**SUBJECT: SURRY NUCLEAR PLANT – NRC OPERATOR LICENSE EXAMINATION  
REPORT 05000280/2017301 AND 05000281/2017301**

## FACILITY POST-EXAMINATION COMMENTS AND NRC RESOLUTIONS

Item #11: RO Written Exam Question #53

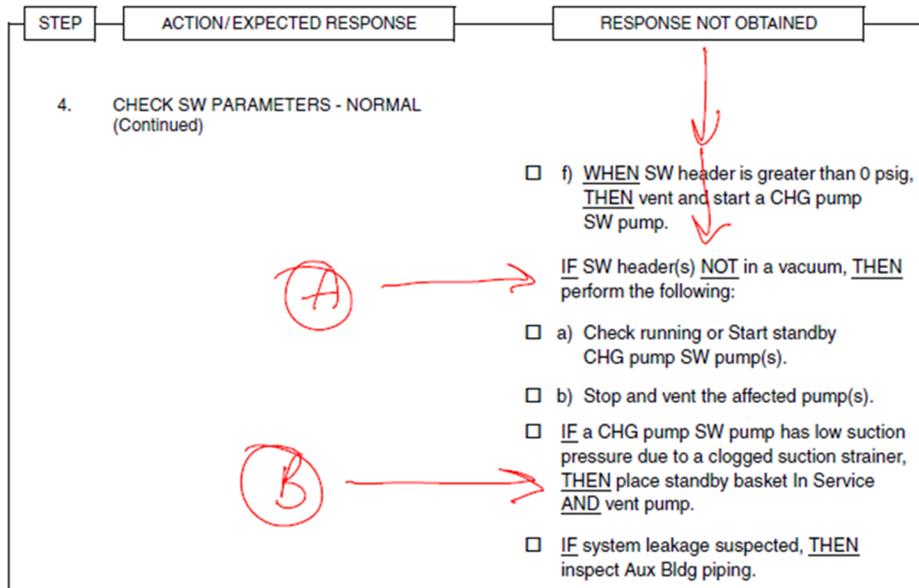
Two applicants contended that answer choice 'B' is also correct, because the sub-steps in Abnormal Procedure 0-AP-12.00, Service Water System Abnormal Conditions, Step 4 RNO are not bulleted and therefore can be performed in any order.

The facility agreed that choice 'B' is also correct, and provided the following marked-up page from the procedure, with subsequent justification:

Sub-steps (marked “A” and “B” above) are of the same level of indent and although “A” is the more appropriate action, “B” contains corrective actions for this scenario. It would be reasonable for a team, performing a scenario with the given conditions, to choose either the “A” or “B” path.

Placing the standby strainer basket in service would correct the issue presented by the question, and is procedurally allowed (the “B” option above). It appears that the question writers and Chief Examiner were focused on pump 1-SW-P-10B not auto-starting as designed, and the most direct and quickest way to remedy the situation would be to start the ‘B’ CHG Pump SW Pump from the main control room (the “A” option above). But locally swapping strainer baskets, while taking more time, would restore normal operating conditions to the ‘A’ pump, so the start of ‘B’ would no longer be necessary.

Therefore, Answer Choice ‘B’ is also correct, so **two correct answers** were accepted for Question 53: ‘B’ and ‘C’
